PRCCP20250372
1st Review
May 2025

Storm Drainage Report

Puyallup Public Safety Building

Figure I-3.3: Flow Chart for Determining MR #5 Requirements

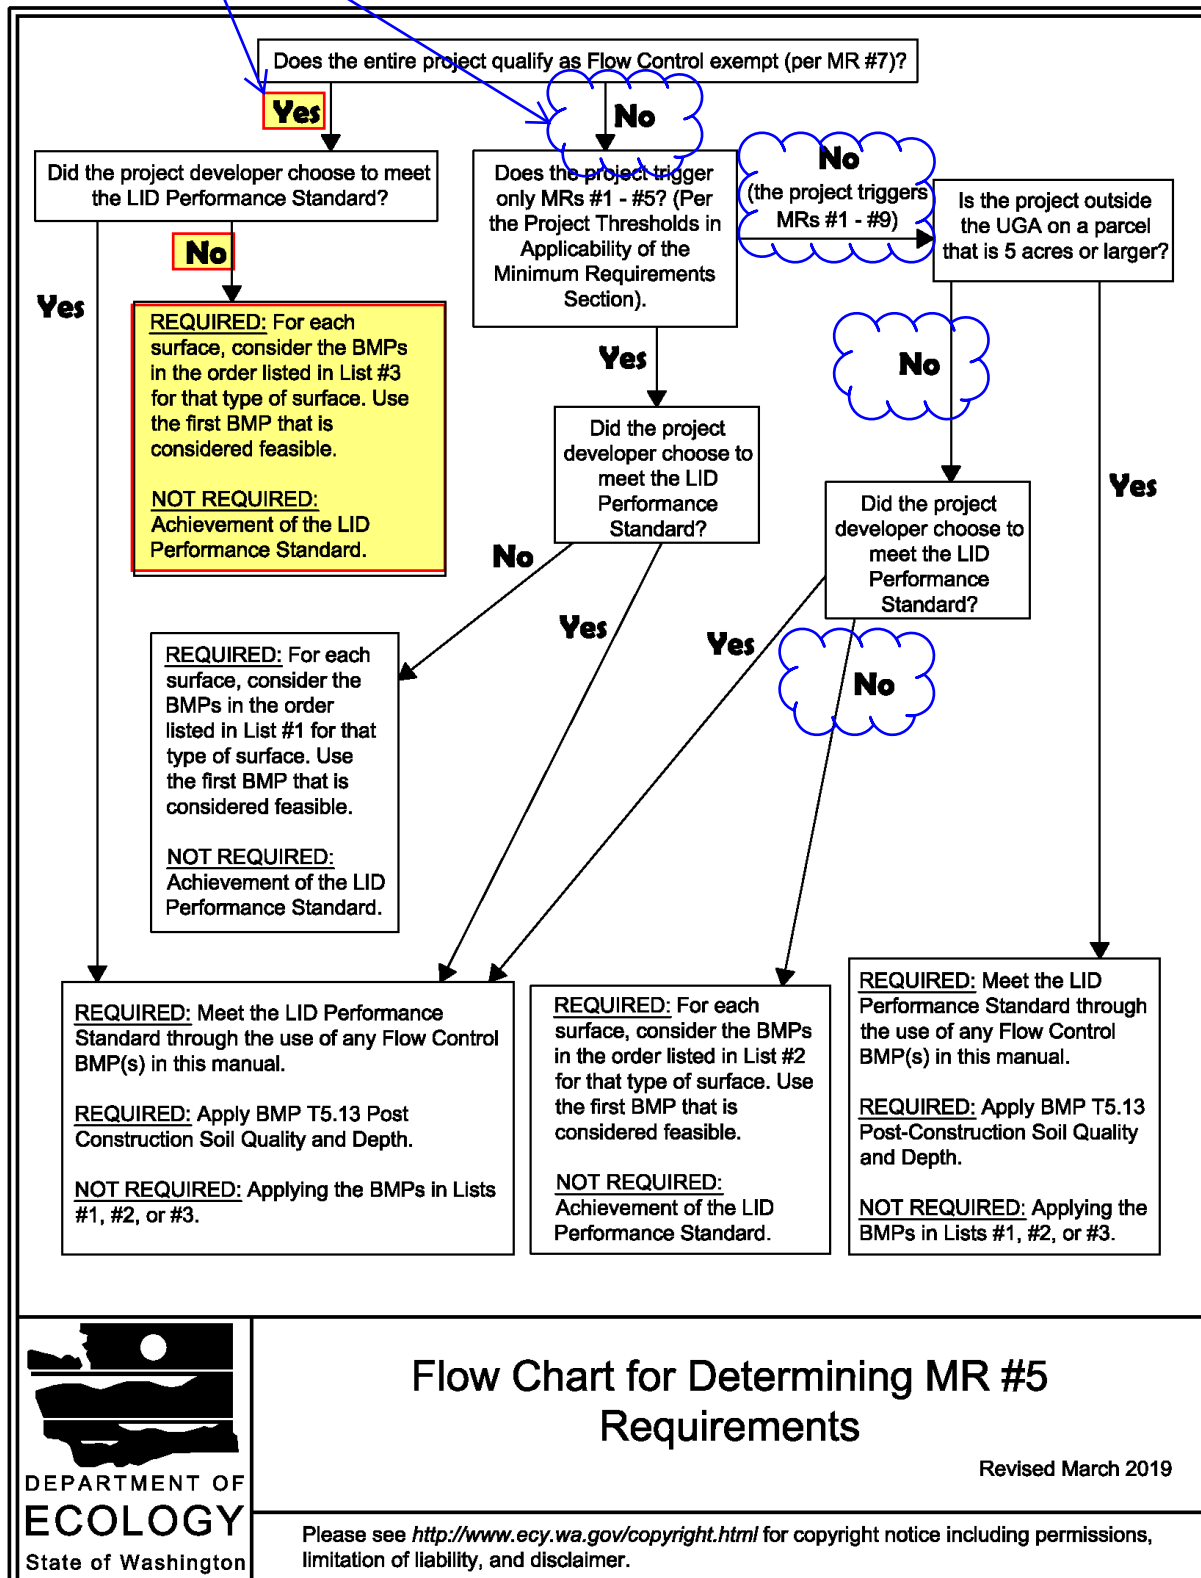
Revise per markups on preceding pages.

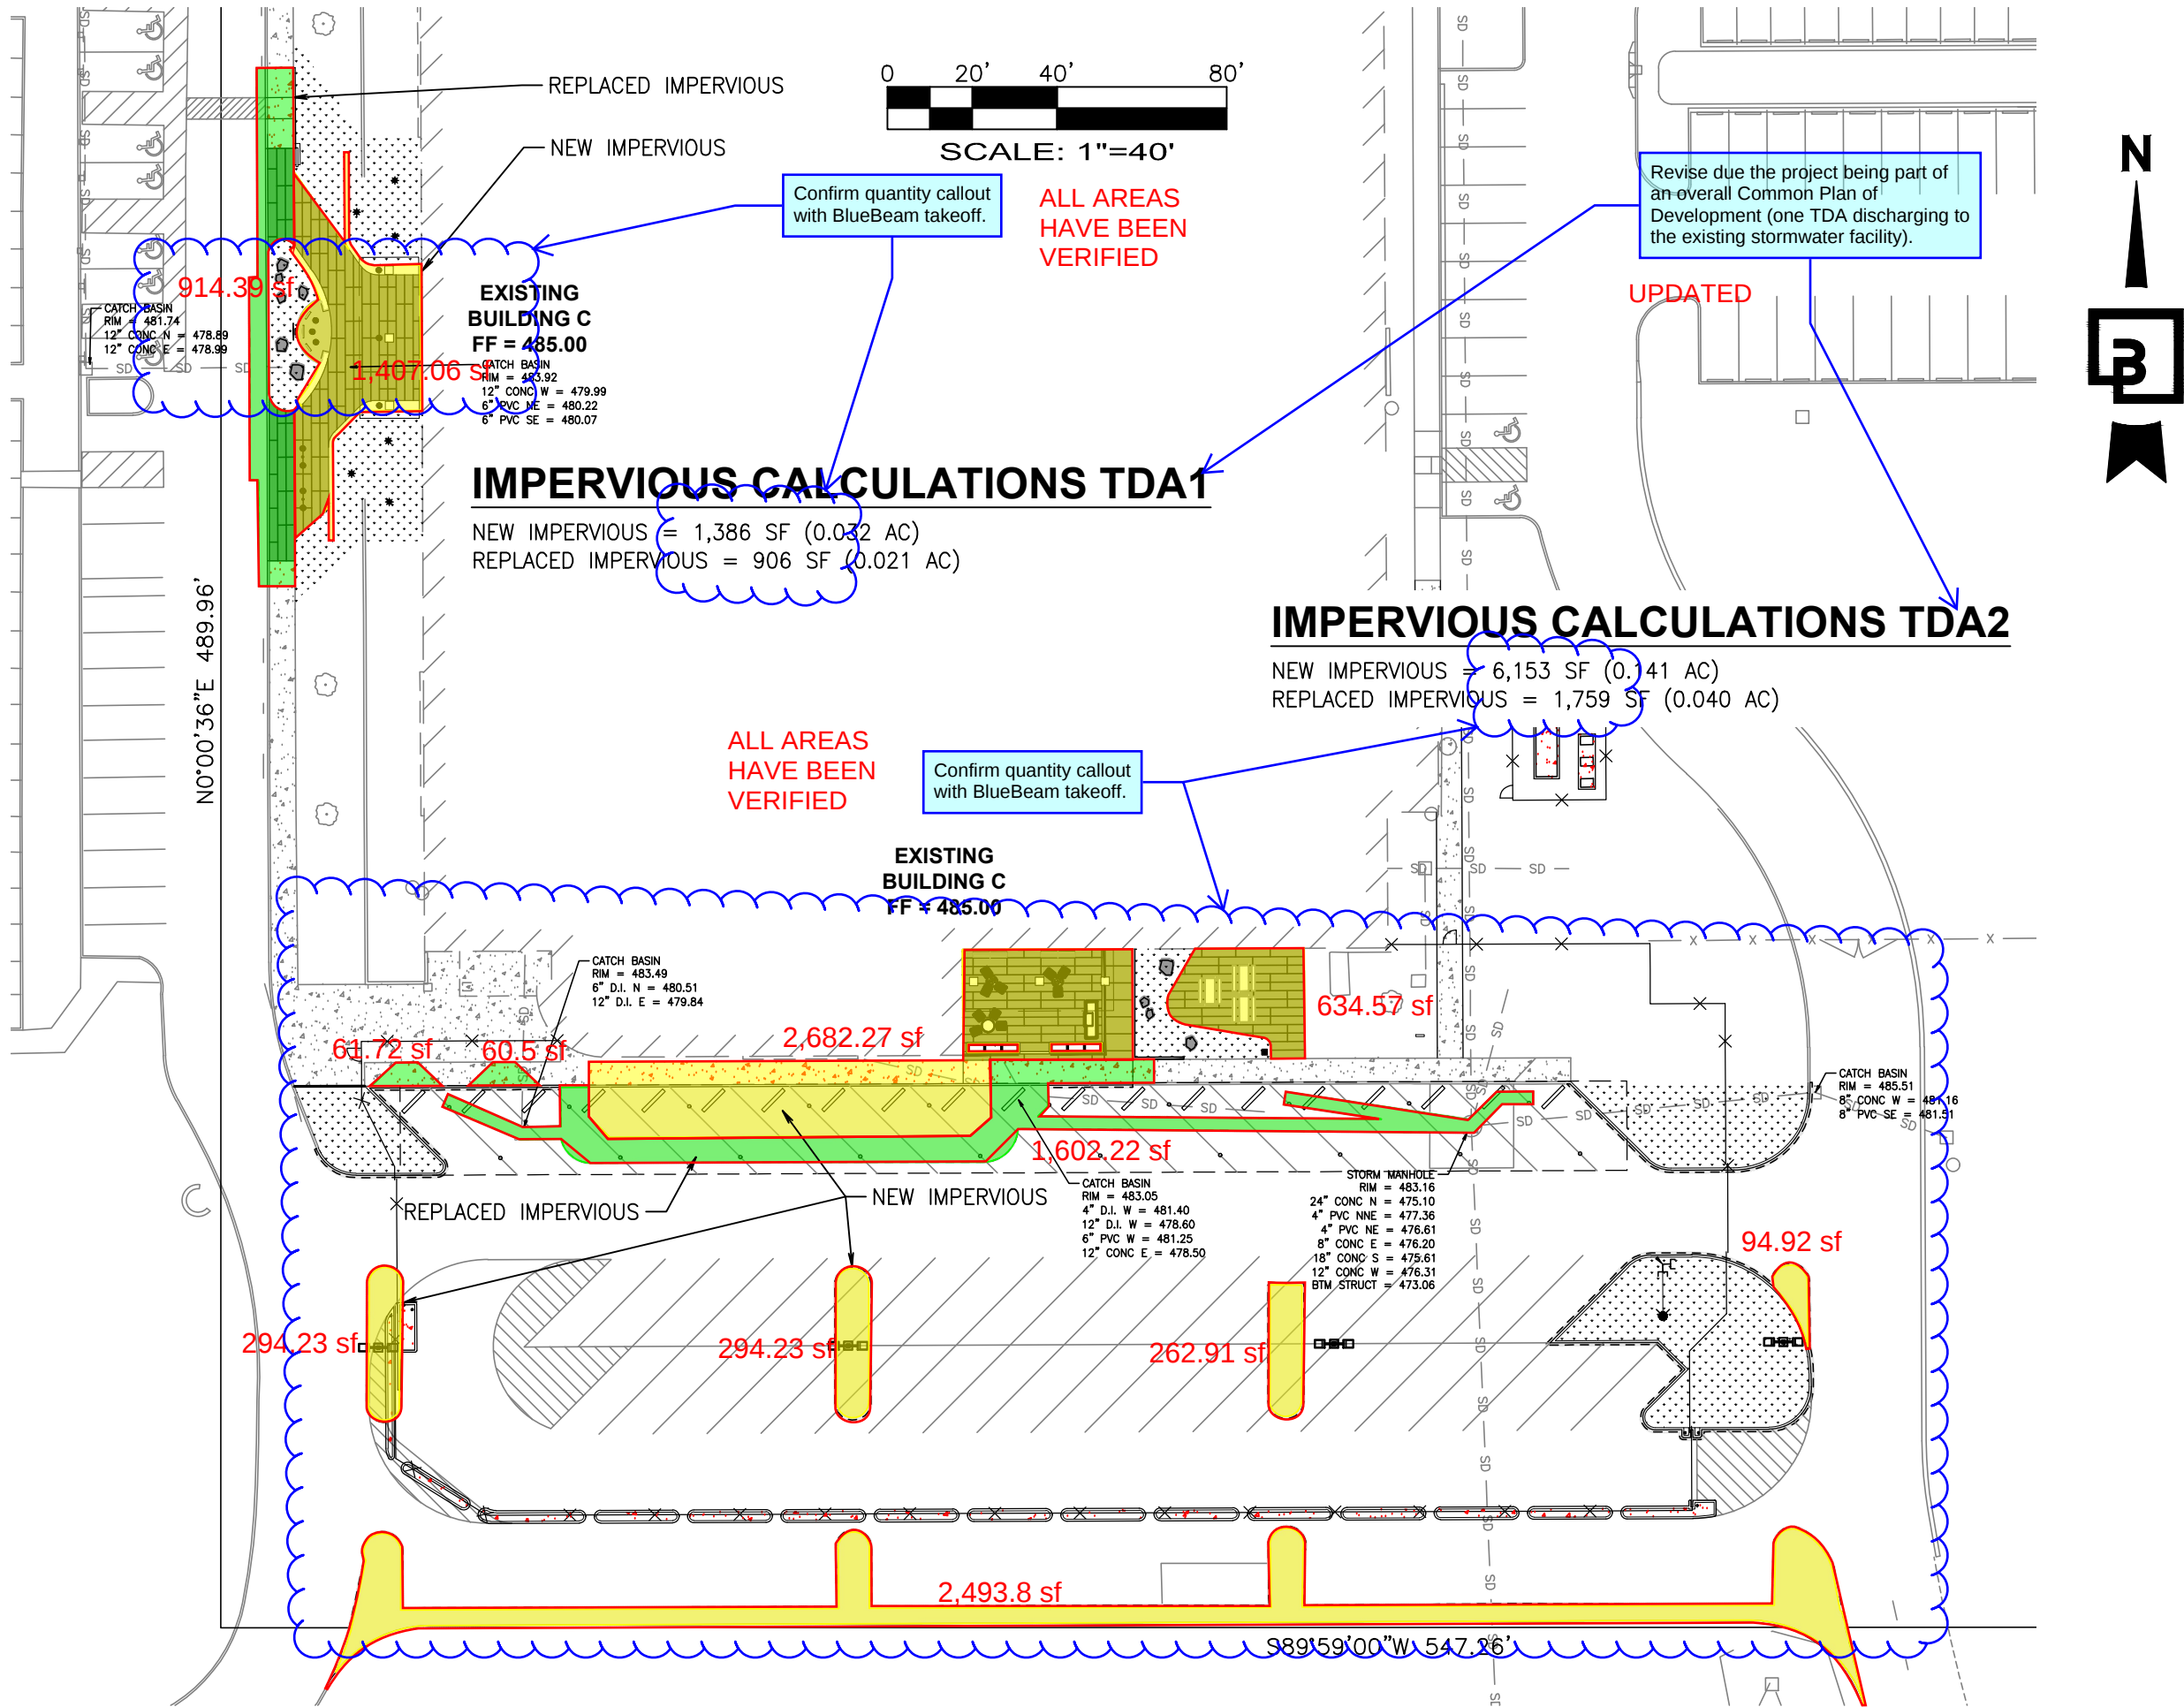
If flow control BMPs are required considering a single TDA, discuss needed improvements to the existing stormwater pond and/or control structure, if any.

NOTED

TDA1

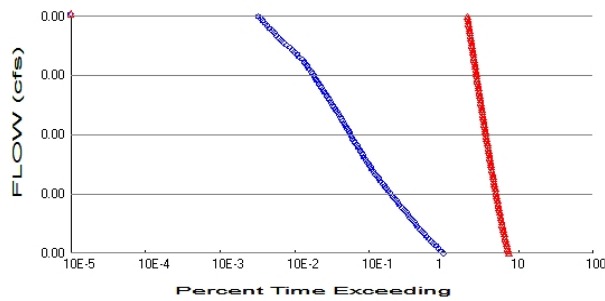
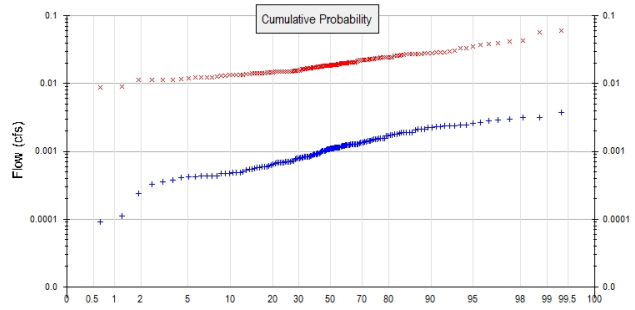
Revise due the project being part of an overall Common Plan of Development (one TDA discharging to the existing stormwater facility).

UPDATED

TDA2

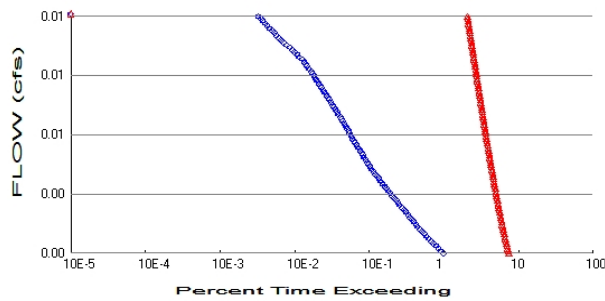
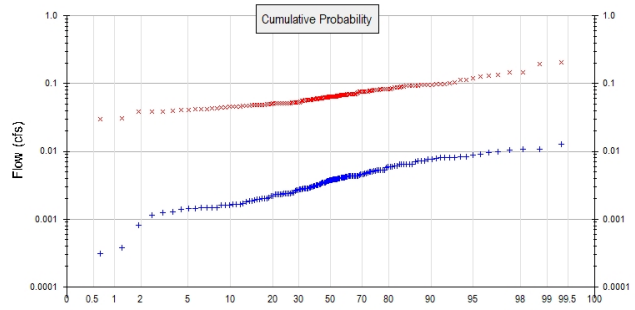
Revise due the project being part of
an overall Common Plan of
Development (one TDA discharging to
the existing stormwater facility).

REVISED
